**Application No:** 2008/0294

**Proposal:** Creation of new access road from Coal Pit Lane to previously approved dwelling.

**Location:** Land adjacent Brook House, Coal Pit Lane, Bacup.

**Report to:** Development Control Committee

SCALE	1:200	DATE	April 08
DRAWN	JDJ	P.P	B.R
CUSTOMER	Mr McGuire		
PROJECT	Proposed Access		
LOCATION	Land to rear of Brook House, Coal Pit Lane, Bacup		
LOCAL AUTHORITY	Rossendale BC

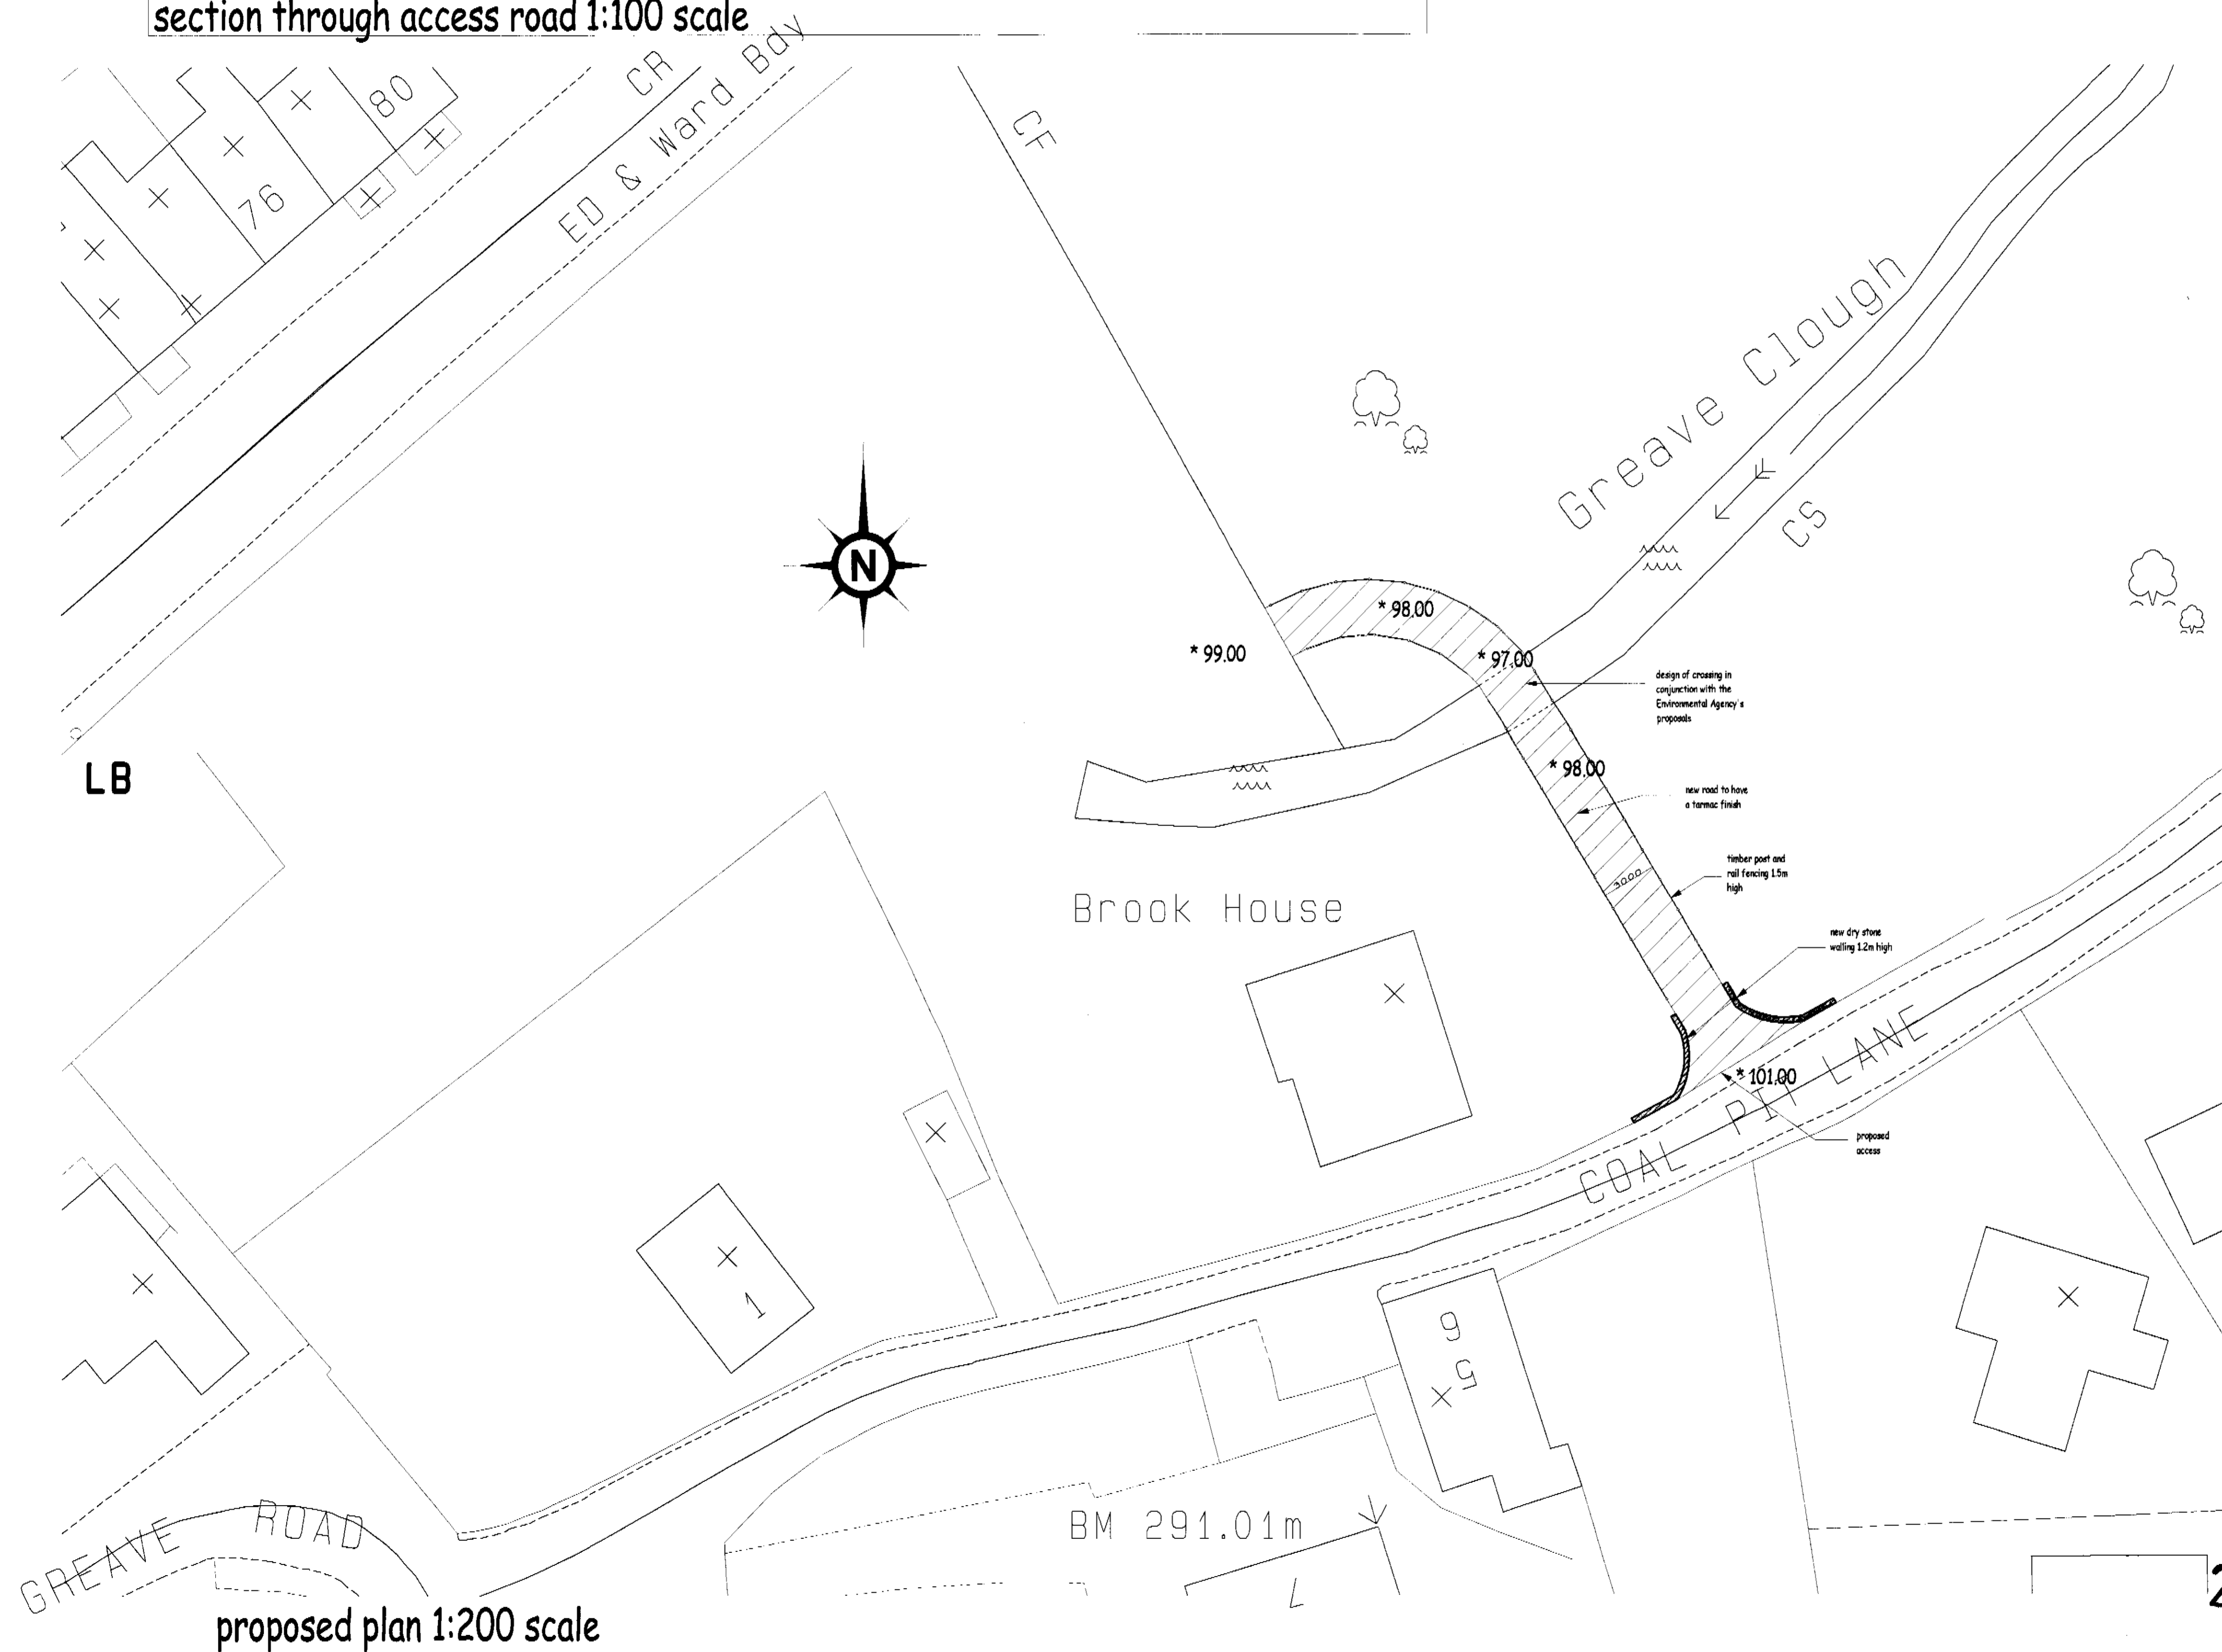
4.1 LCC (Highways) - Recommends that the application be refused on the grounds:

1. The first 5m of the access road should be both level and 4.5m wide to allow vehicles to pass.
2. The walls adjacent the entrance should be of a height less than 1m to maximise sight lines.
3. The gradient between the lowest point and highest point should not exceed 1:15.

The highway authority is concerned that the proposed access road in would be inadequate in terms of its width, gradient and provision of satisfactory sight lines. The authority believes that the access road, due to its restricted width, steep gradient and without the benefit of any passing places, would be to the detriment of highway safety which is unacceptable.
